PLANNING RESPONSES
SUNLIGHT HOUSE
APRIL 2023

EXTERNAL ALTERATIONS

INTERNAL ALTERATIONS

10. SUBDIVISION OF OFFICE FLOOR

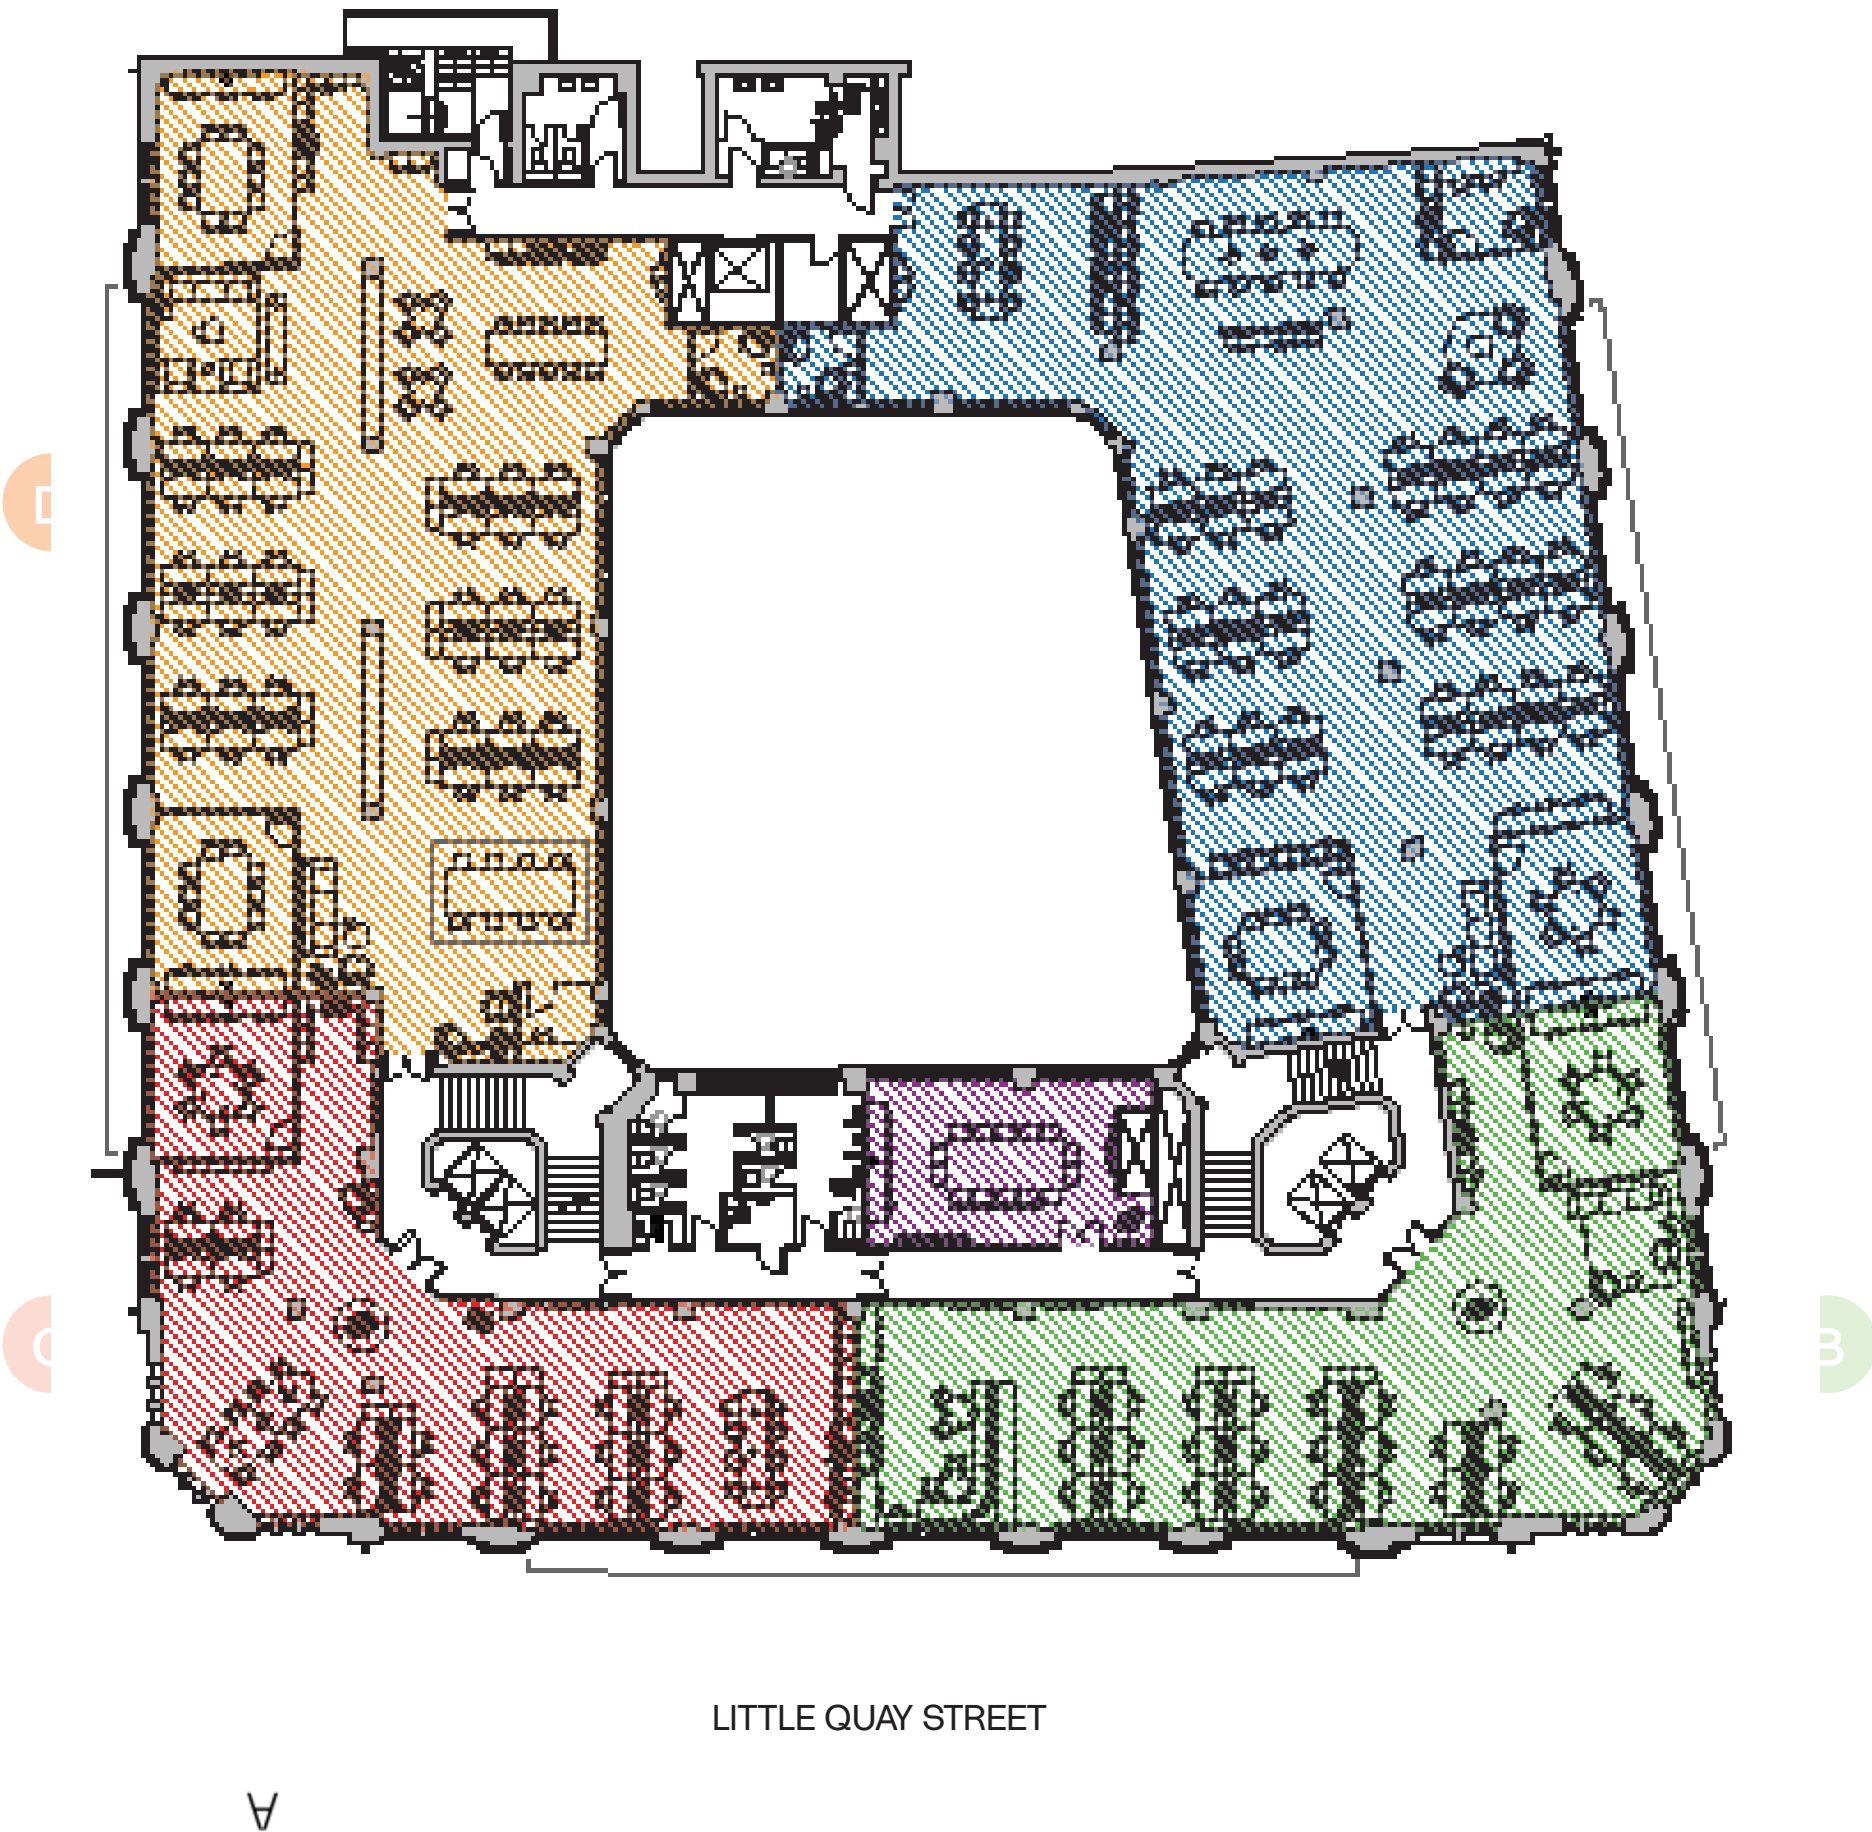
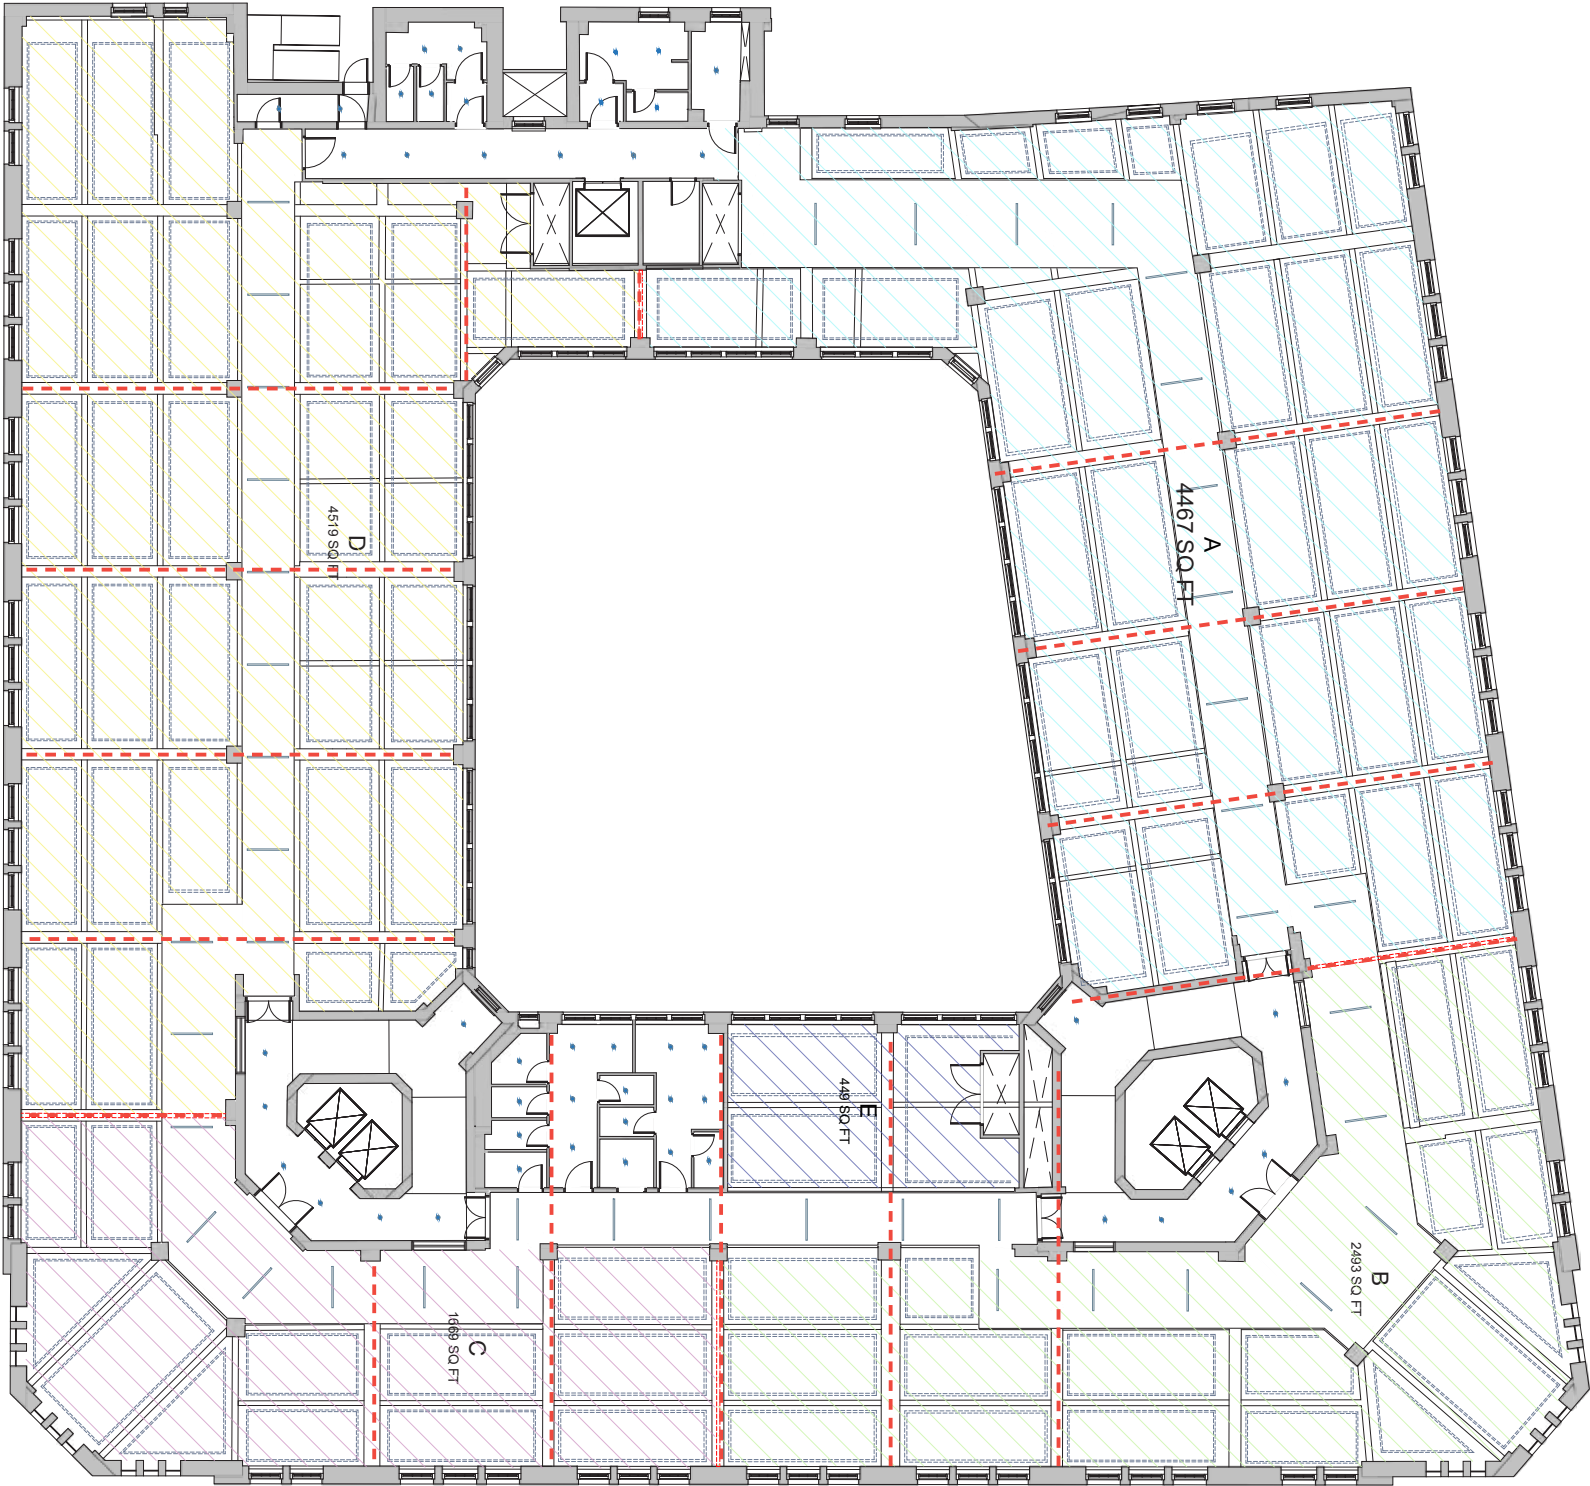
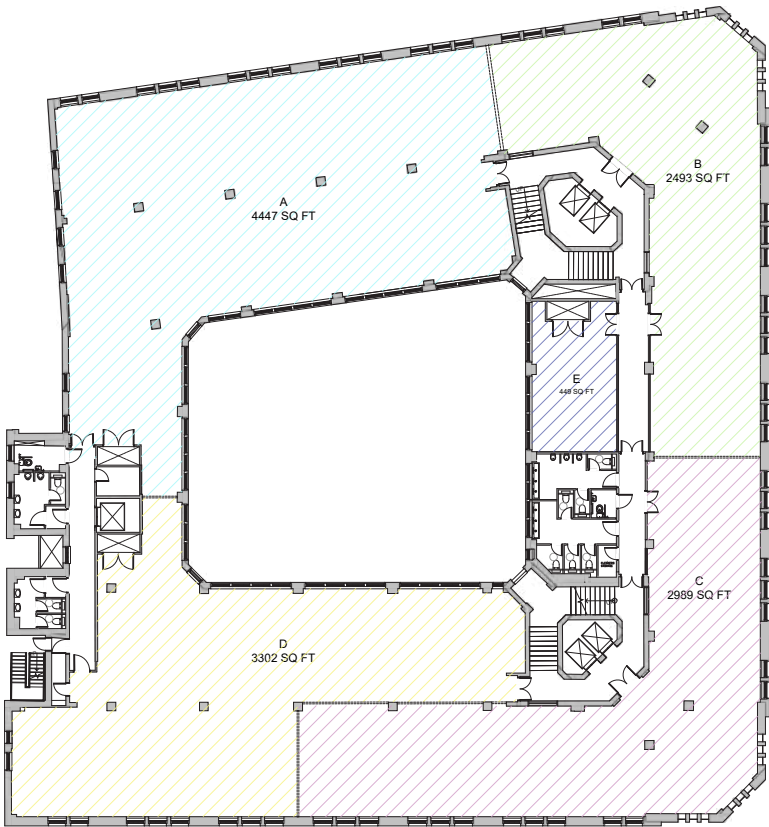
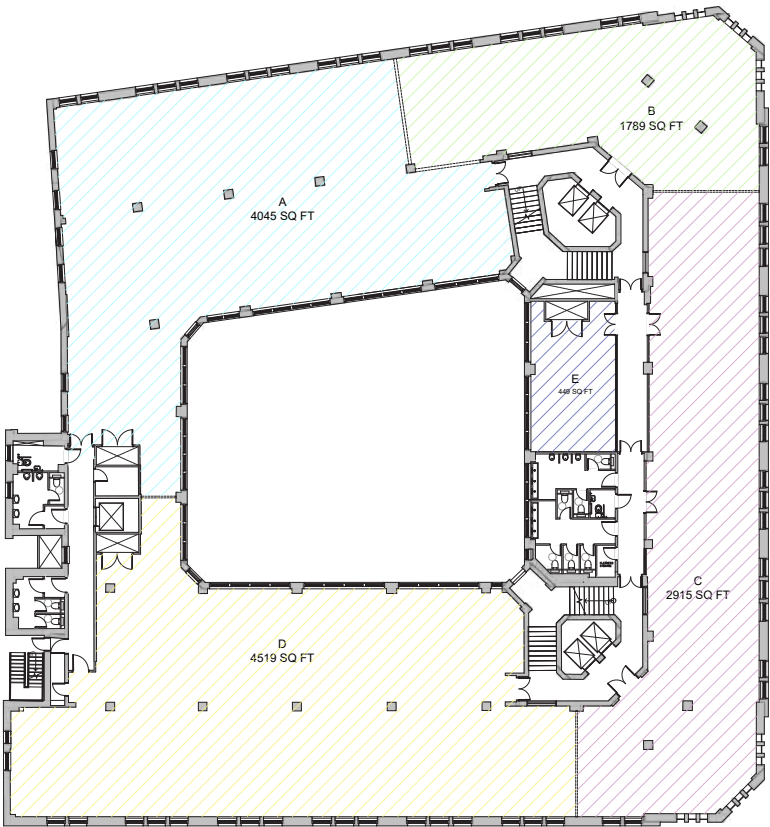
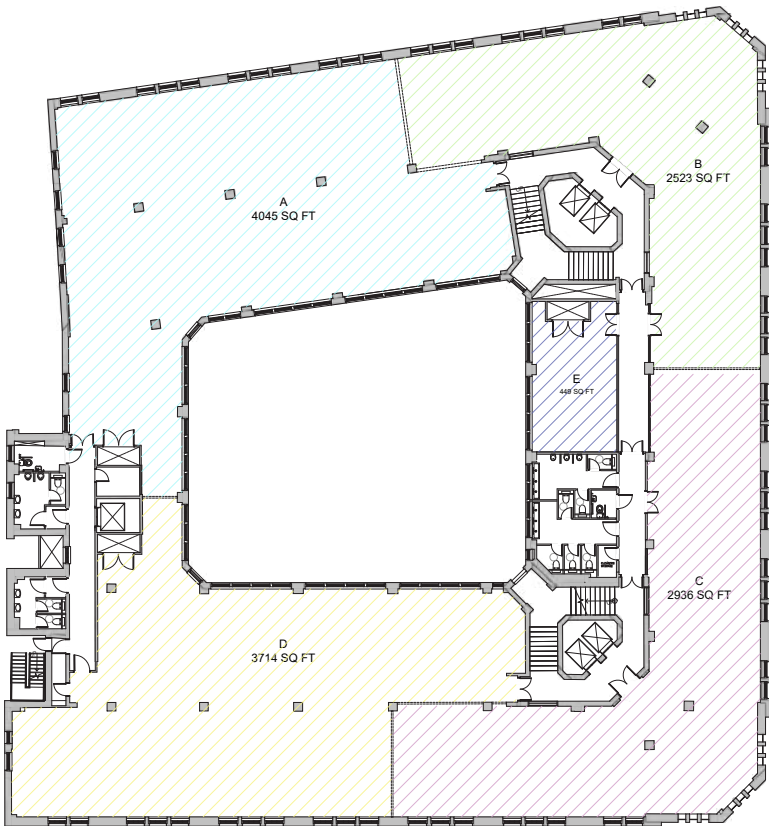
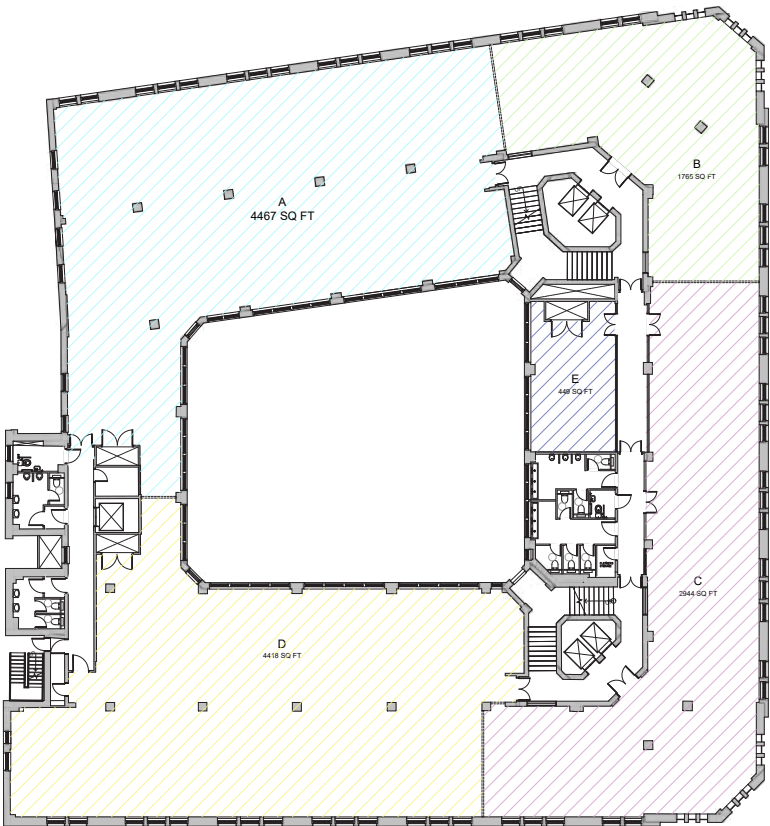
We have discussed previous the approach to subdivisions. We are not going to be able to accept indicative locations at this stage so we will need to understand this in a bit more detail. Future partitions will need LBC as discussed unless it is minor works associated with tenant fit out (which we can have a condition for).

The maximum a floor would be proposed to split into individual tenancies would be 4 (with small shared 5th room) as shown. It would be positive to be able to discuss a revised tenant fitout guide to the previously approved confirming any potential meeting room subdivision within that space.

Example tenancy splits on a single floor using structural lines only. (dashed red lines)

Floor would be split into no more than 4 key tenancies with small suite/shared space between main cores.

LEVEL 10 - EXISTING

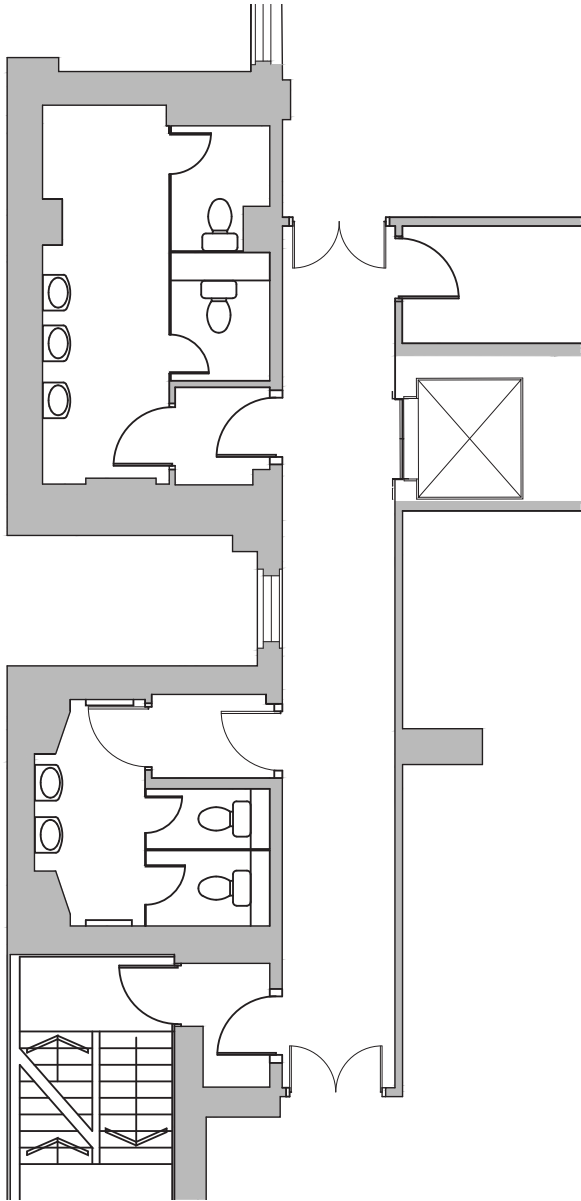
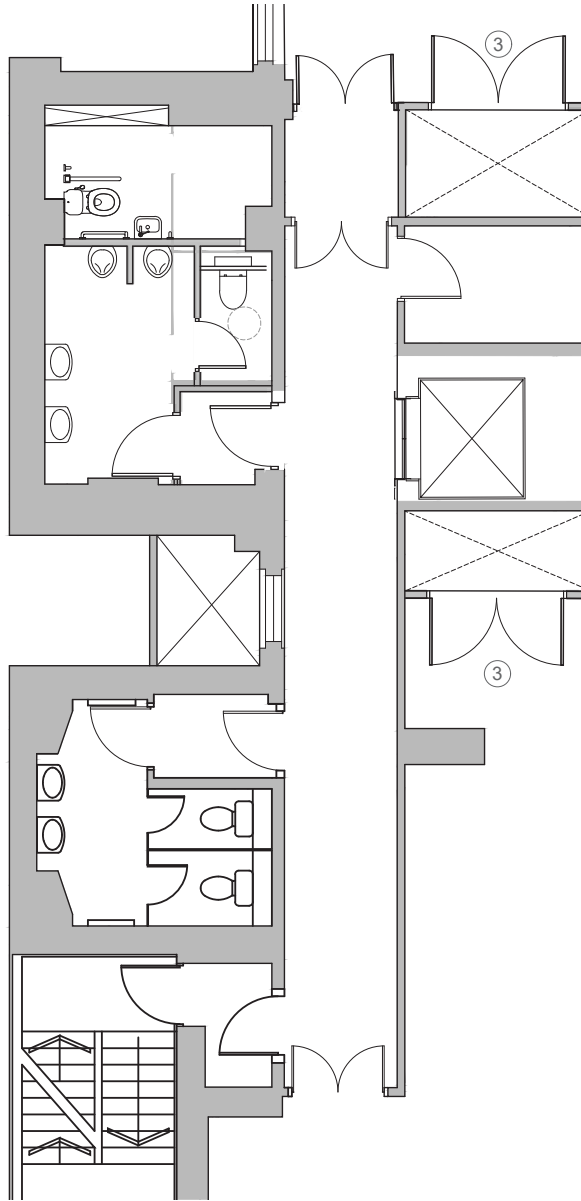
We are going to need further details on the historical significance of the walls to the northern most WC units in the west block on levels 2, 3, 6 and 7. It is not clear if these are modern

The subdivision wall that has been added on various levels is a modern partition used to create kitchenettes, showers, accessible WCs in the originally larger male WC. Please refer to WC audit document for overall picture of current WC conditions. We are using it to introduce an accessible WC to all levels at both east and west cores to improve amenity within the building.

TYPICAL SECTION A-A @ 1:50

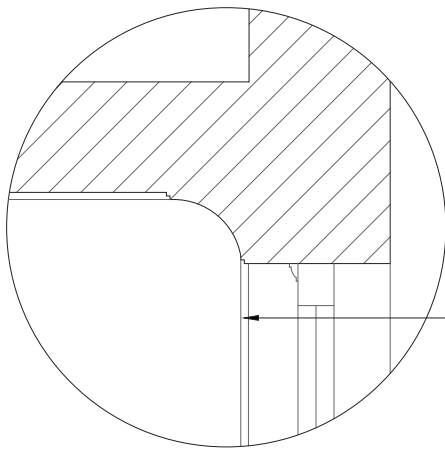
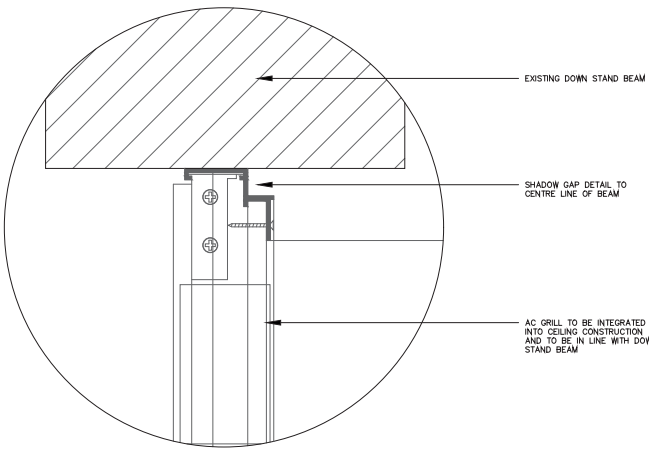
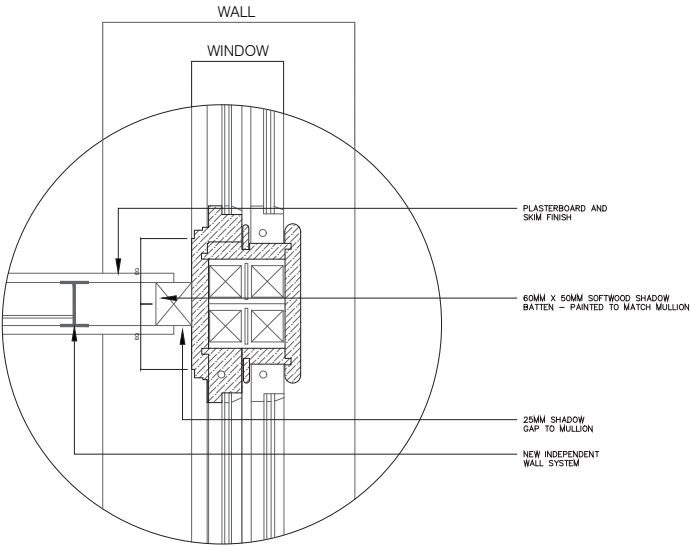
We will also need further details of the glazed wall panels and new internal doors (proposed and existing cross sections) so we can understand the impact on historic fabric.

The glazed wall panels are proposed to interface in the same way as other partitions. The central set of glazed panels interface with the bulkhead rather than the ceiling coffer to further ensure a satisfactory condition. Additional drawings are to be supplied of proposed elevations.
